Re Minor Modification Sage 1509 North Jackson Apartments Engberg Anderson Project No. 132251.01 EA File Name: P:\2013 2248\132251 Dominion Properties\1-Project Administration\6-Codes & Zoning\Zoning\8-13-13 Minor Modification\ 2251.01-Sage 1509 Jackson Apartments Koster 9-10-13

EXHIBIT 'A' 8-13-13

9 GUARDRAIL GR-1 4532 SOALE: 3/4"=1"-0"

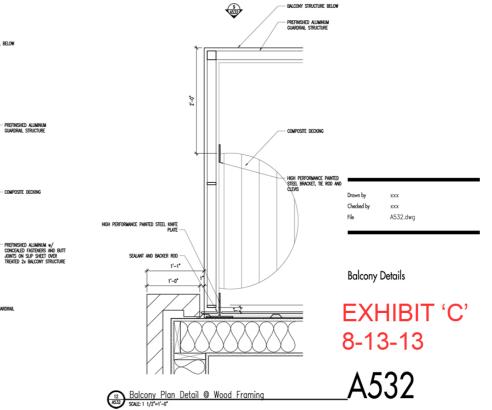
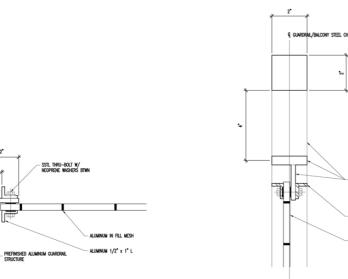
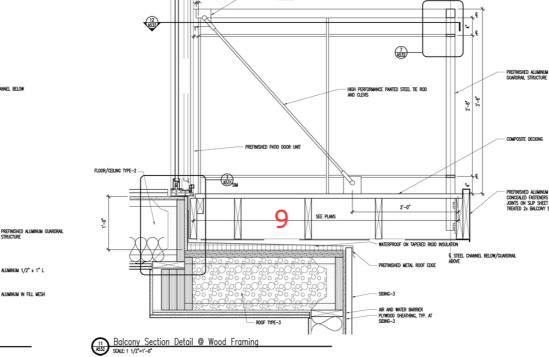
- 3. Cement panel will be used in lieu of polyaspartic coating per the approved DPD. (See exhibit B)
- 4. Balcony guardrails were changed to wire mesh in lieu of glass panels per the approved DPD. (See exhibit C)

- 8. Entrance along Jackson Street has changed to include less glazing. (See exhibit B)
- 9. Typical balcony construction will be wood with a perforated aluminum soffit and aluminum fascia in lieu of perimeter steel channel as indicated on the Issued for Permit set dated 8-2-13. (See exhibit C)

NOTE: PREFINISHED ALUMINUM GUARDRAIL WITH ALUMINUM MESH IN-FILL IN LIEU OF PAINTED STEEL GUARDRAIL WITH HEAVY GLASS IN-FILL PER APPROVED DPD.
